**City of Puyallup
Fire
REVIEWED
FOR
COMPLIANCE**

City of Puyallup Development & Permitting Services ISSUED PERMIT	
Building	Planning
Engineering	Public Works
Fire	Traffic

Amerex kp KP275 suppression system ul 300

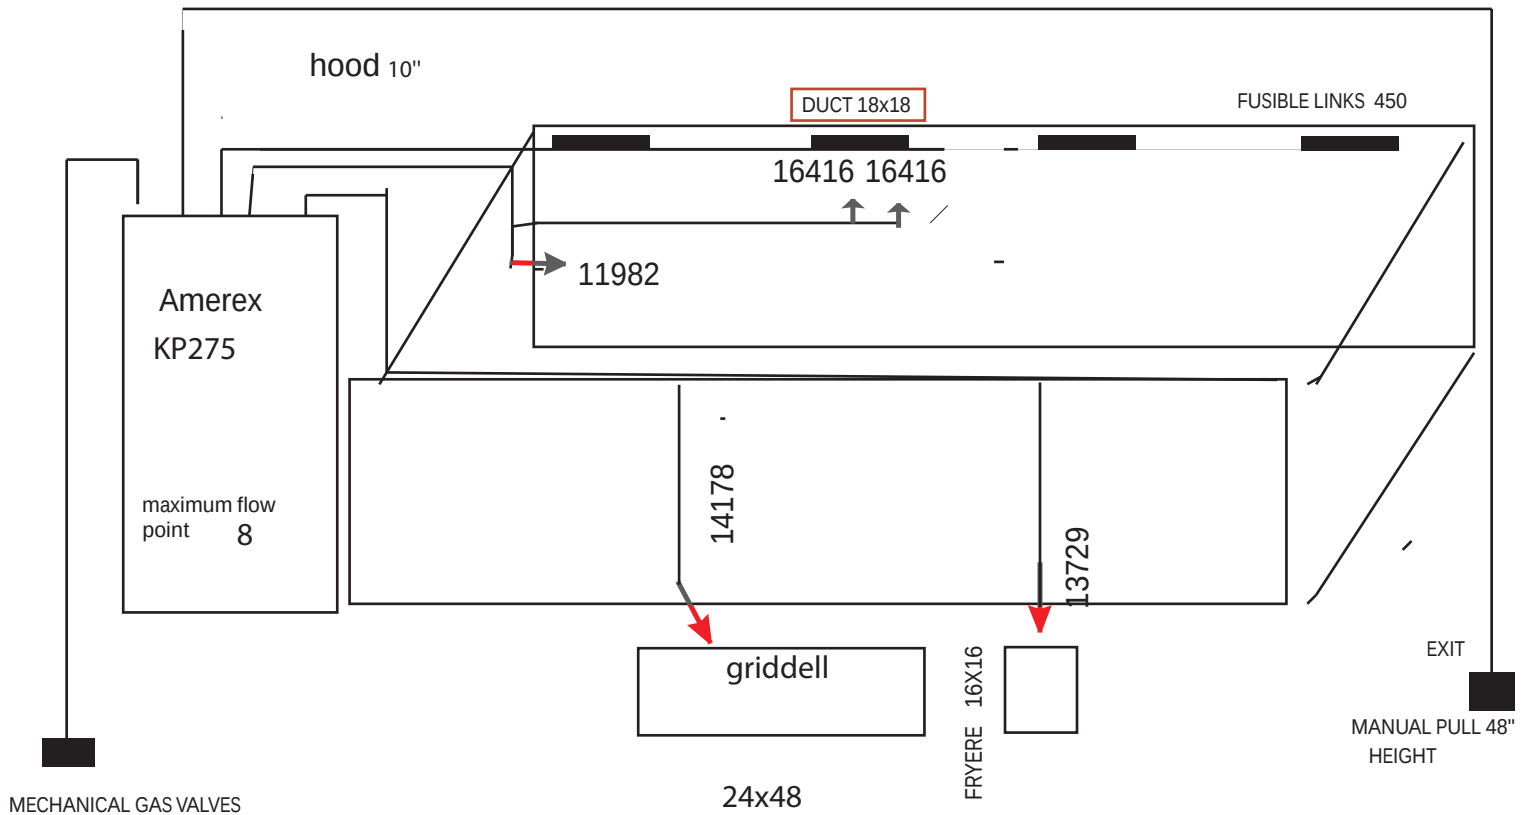
All cooking equipment under the hood shall shut off when system is actuated & make up air unit and gas shut valve to fire suppression system shall be connected to the fire alarm system
